3P21
Carolina Power & Light Company

FILE: NG-3514(B)

SERIAL: NO-80-761

BRUNSWICK STEAM ELECTRIC PLANT, UNIT NO. 2
DOCKET NO. 50-324
LICENSE NO. DPR-62
CYCLE 4 RELOAD ANALYSIS AND EOC-RPT
DOCUMENTATION OF VERBAL RESPONSES

Flow Coastdown Curves

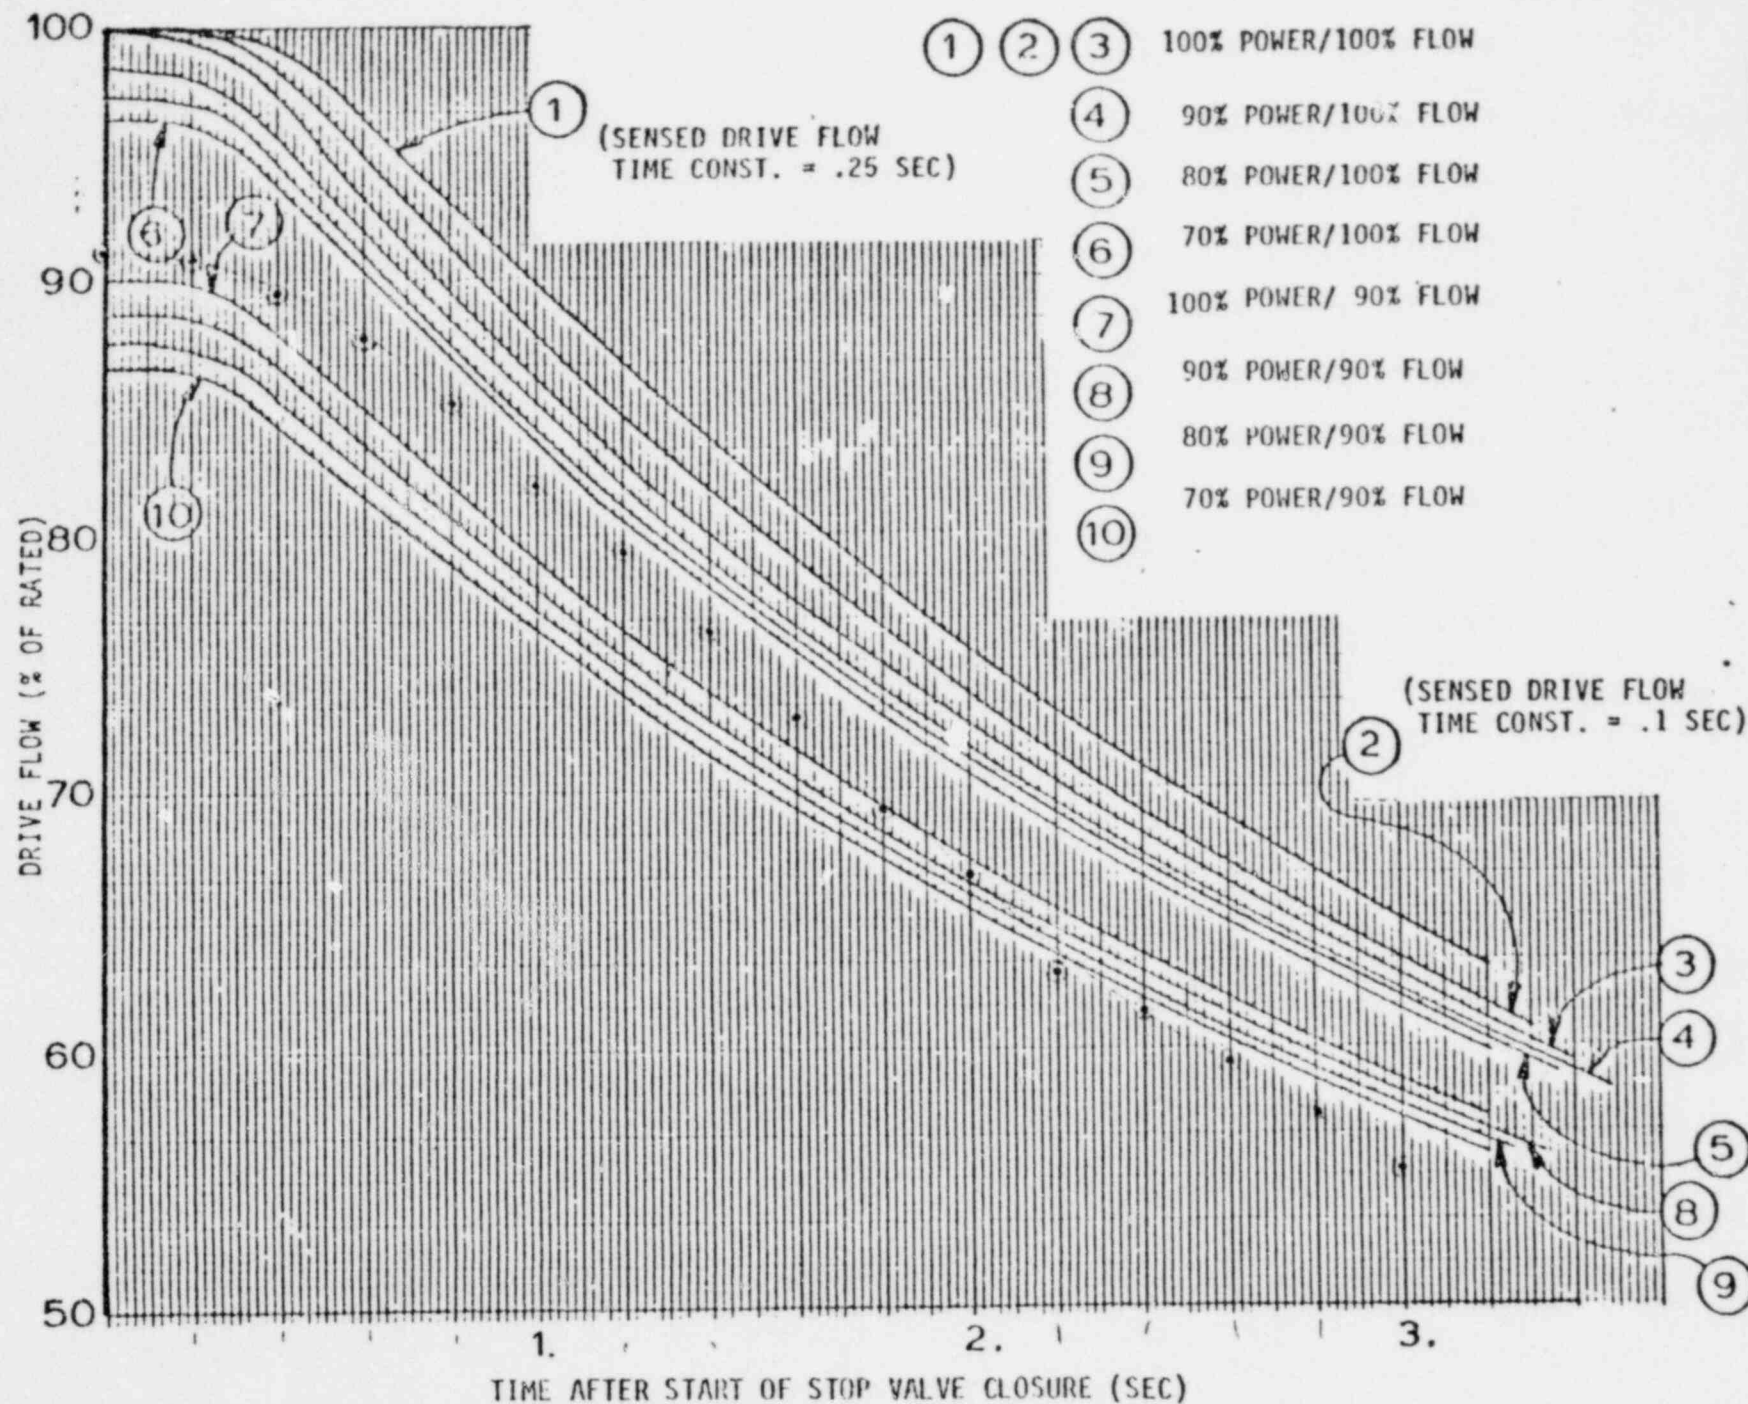
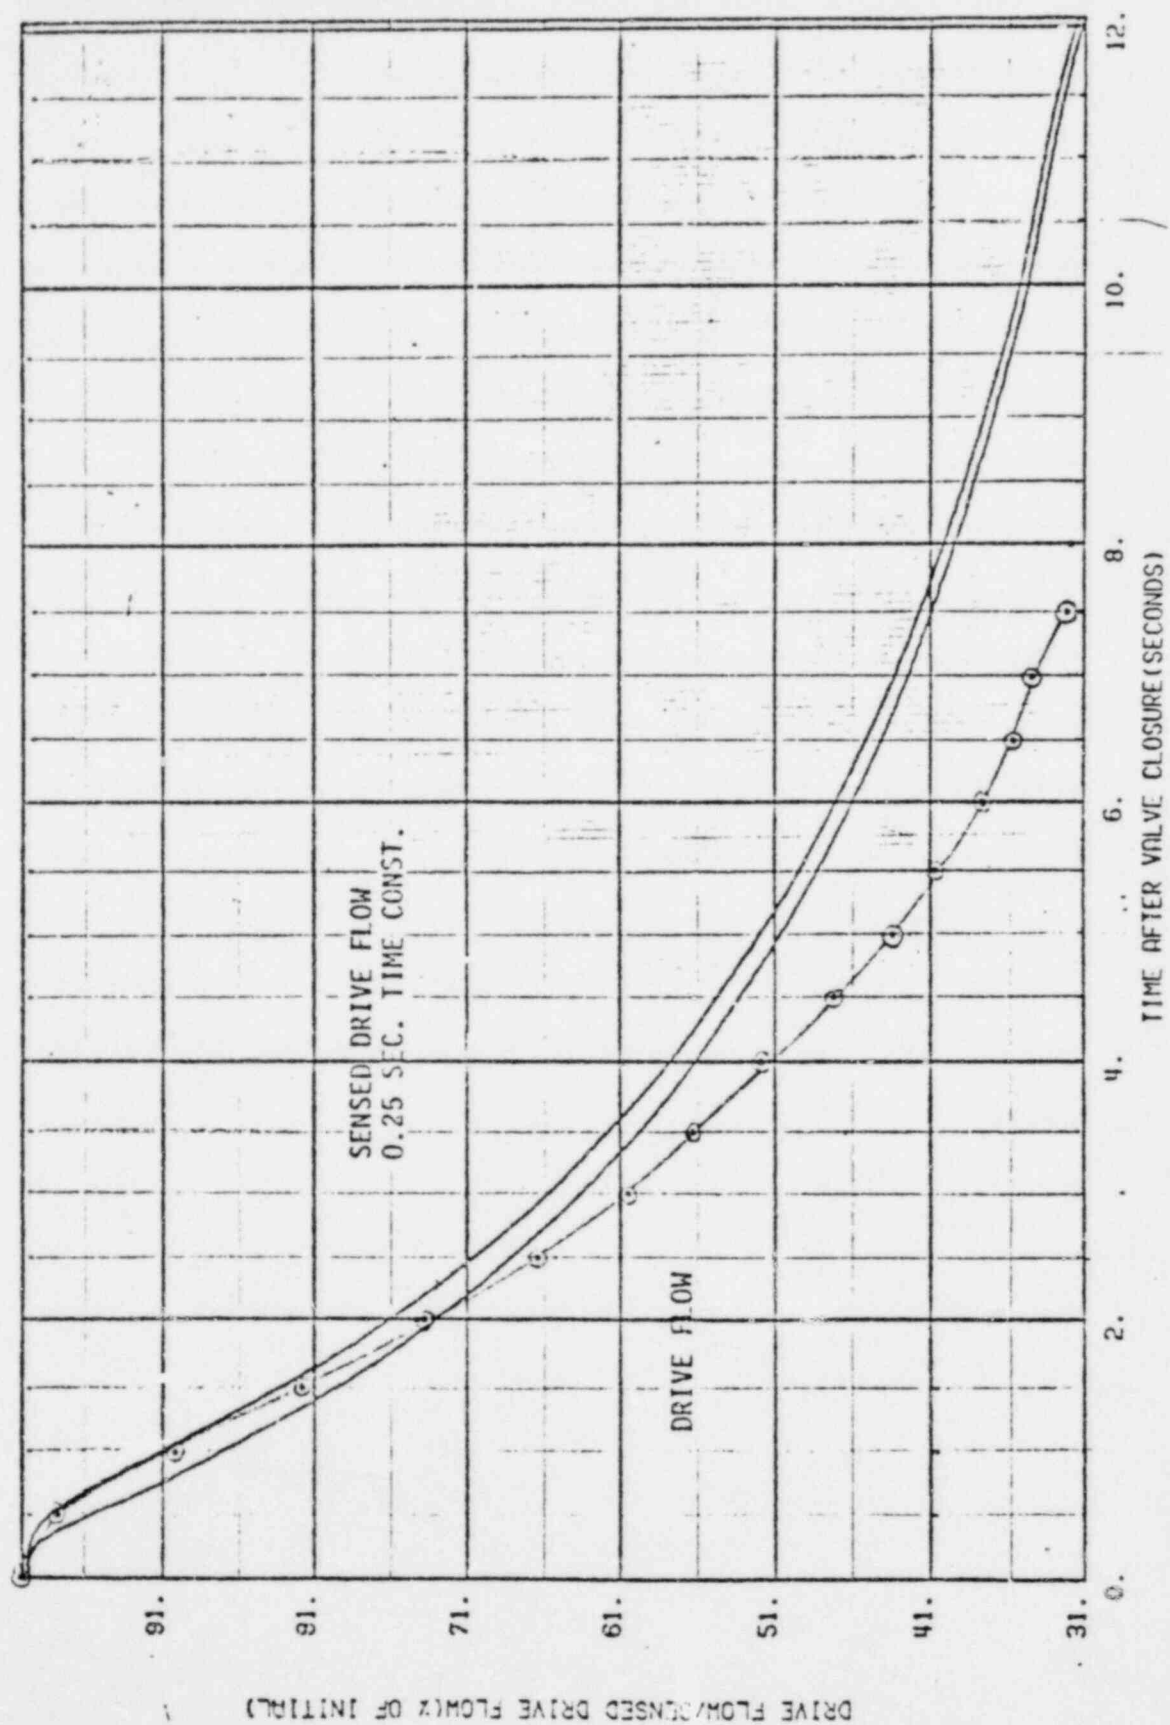
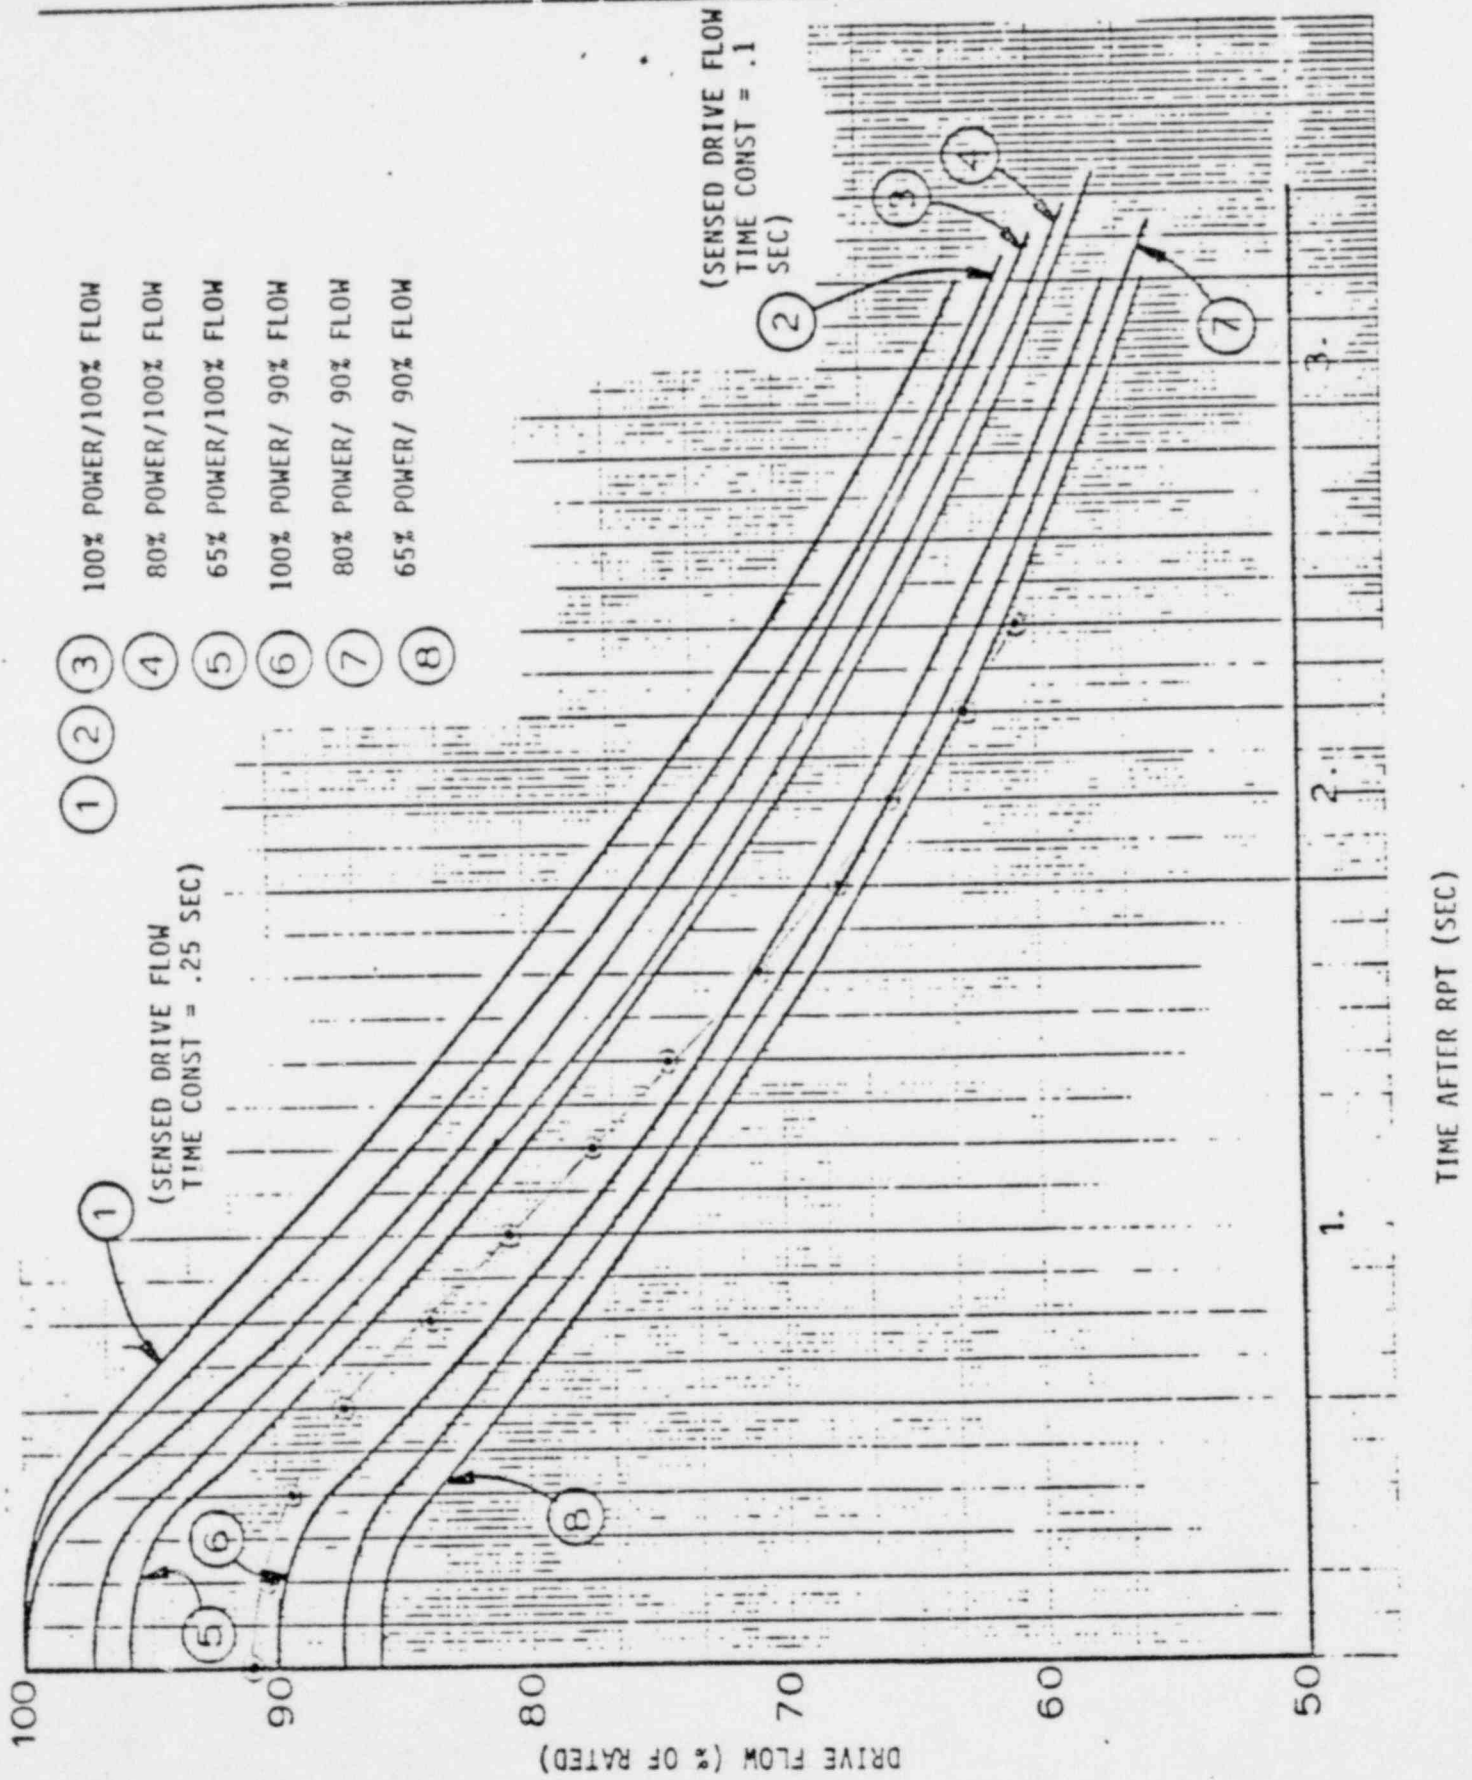
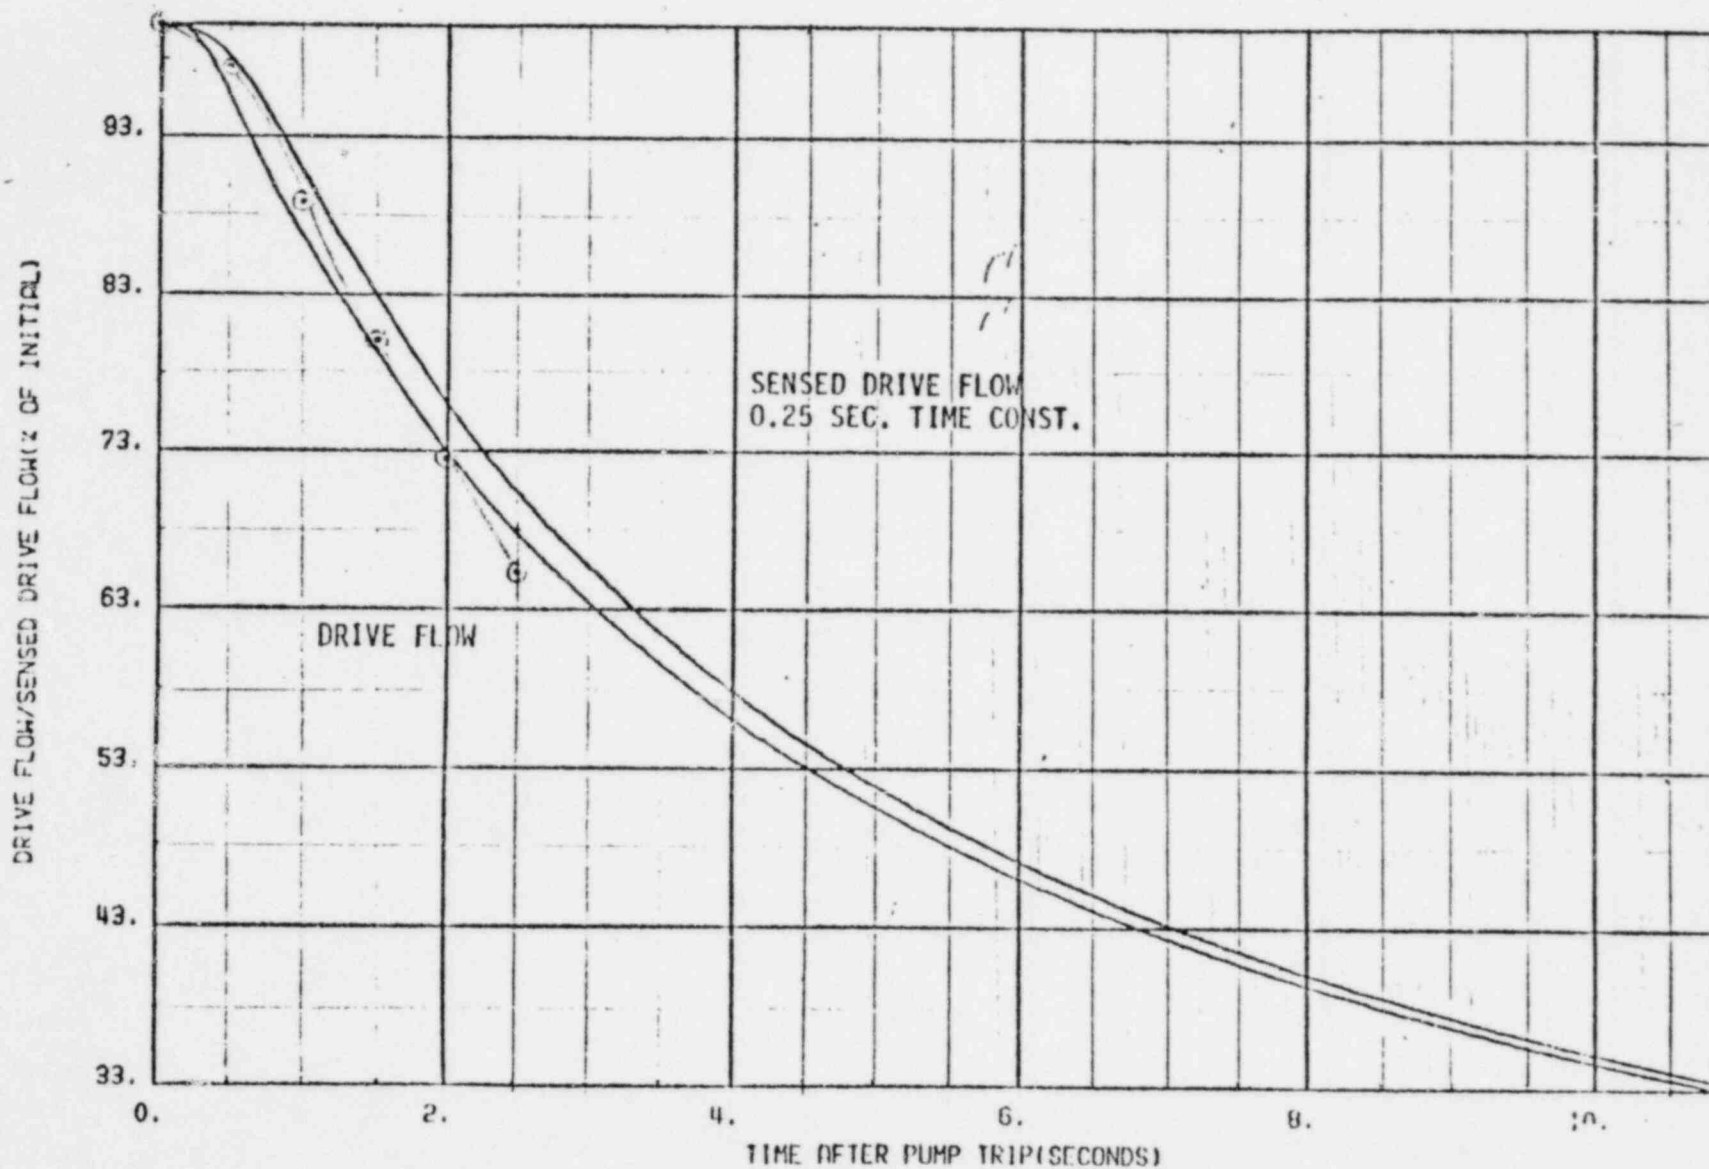
Brunswick Unit 2 tested its EOC-RPT system as it was shutting down for refueling at the end of Cycle 3. The test was performed at 73% power and 97% core flow. The criteria to be met was for the EOC-RPT breaker response time to be less than or equal to 175 msec. and the recirculation pump flow coastdown curve was to fall within the coastdown curve predicted by General Electric (GE) for the BSEP-2 system. The indicated response time (175 msec.) was that assumed by GE in their EOC-RPT analysis. Refer to Attachment 1 for an outline of this assumption. The predicted flow coastdown curve was based on Brunswick-specific input data and the calculation of an inertial constant calculated from the pump/motor nameplate data, to which a 15% design factor for conservatism has been added. The measured response time was 105 msec., and, as can be seen from Attachment 2, the measured coastdown curve falls within the bounds of the predicted curve. A summary of the parameters measured for this test is presented in Attachment 3. The 105 msec. response was determined from two components: (1) 20 msec. from initial turbine stop valve movement to the 90% open position switch actuation, and (2) 85 msec. from the 90% open position switch actuation to load current arc suppression.

The predicted coastdown curve is conservative for Cycle 4 and future cycles because the curve was calculated with an additional 15% inertia included in the pump/motor inertia calculation which tends to increase the coastdown time. Since there is no known mechanism which would increase the pump/motor inertia, this predicted curve will be conservative.

Since the EOC-RPT system was tested, a modification was installed on the recirculation pumps which required an increase in diameter of the pump shaft and associated parts. This change increased the pump/motor inertia by only 9.0 lb-ft². GE has evaluated this change, which was less than 0.1%, and has determined it to be insignificant with regard to the predicted coastdown curve.
